Aiken Intermediate – Bus Transportation Office Aiken County Public School District

October 6, 2026

Addendum No. 02

Questions

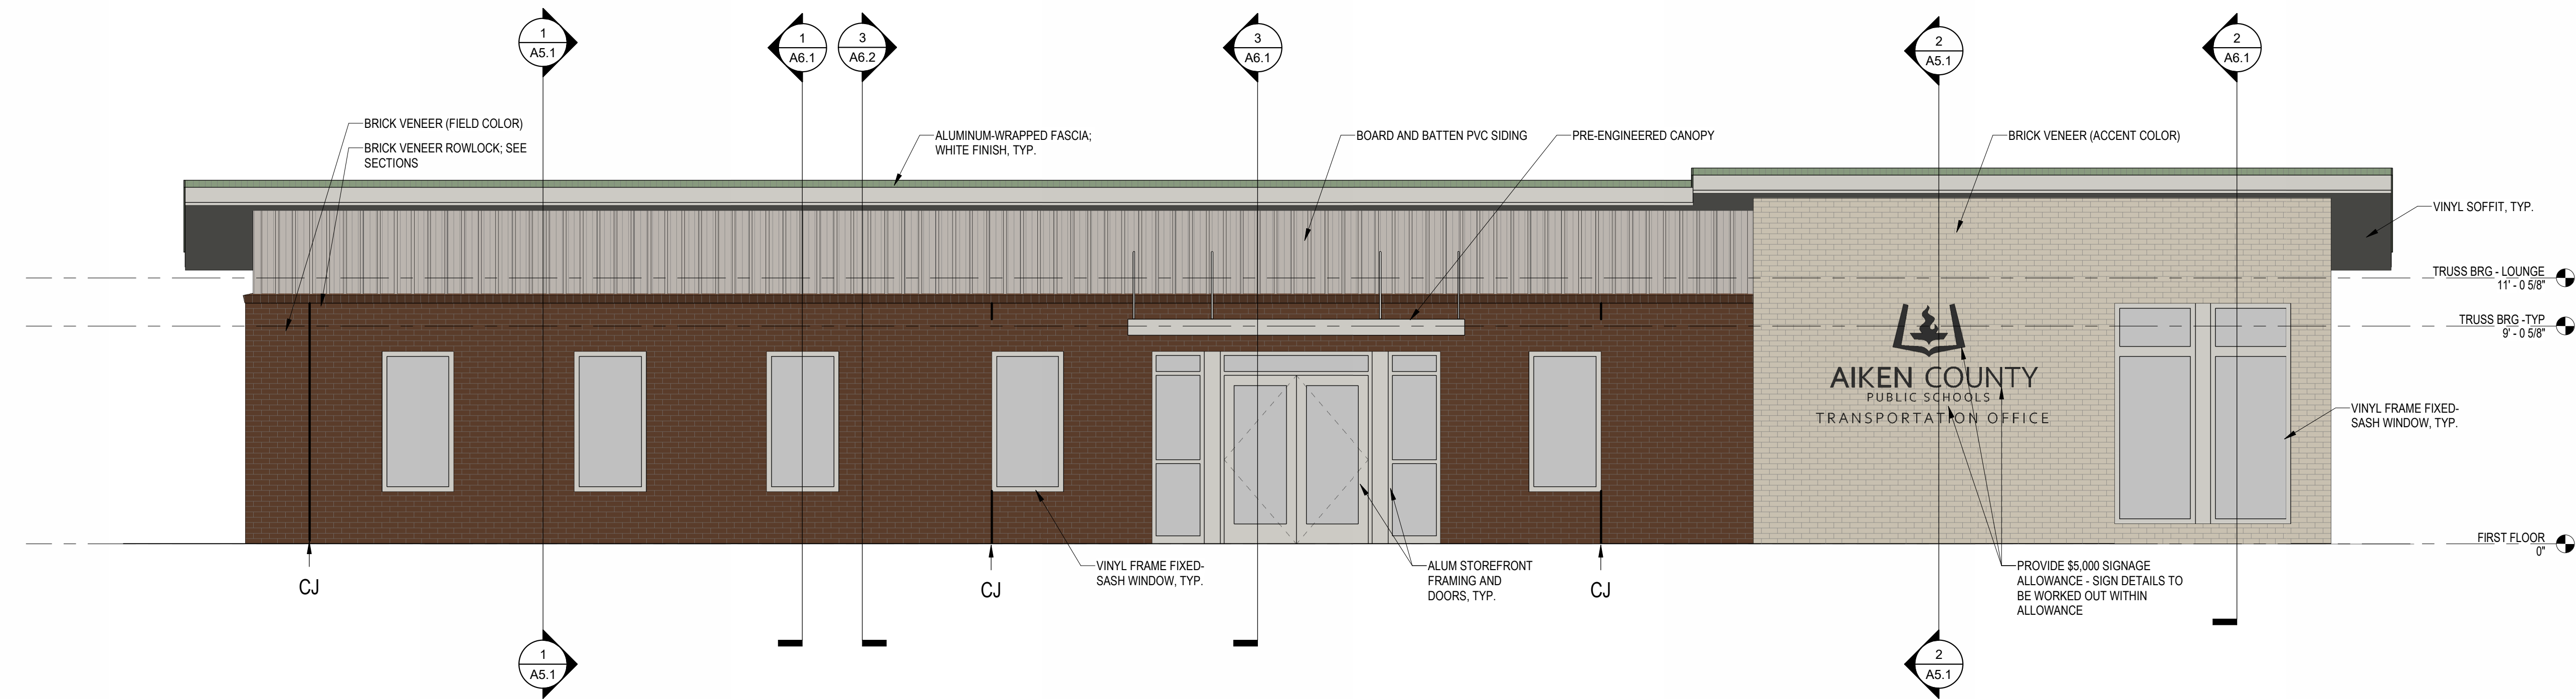
1. Drawing A4.1

- a. See revisions regarding exterior vinyl siding finishes.

1. The Ply Gem vertical siding specified doesn't appear to be available in the color specified. The color options affect the price per carton. Is there another color that may be acceptable?

Yes, please provide this material in the color, "Sand". See the revised A4.1 sheet attached.
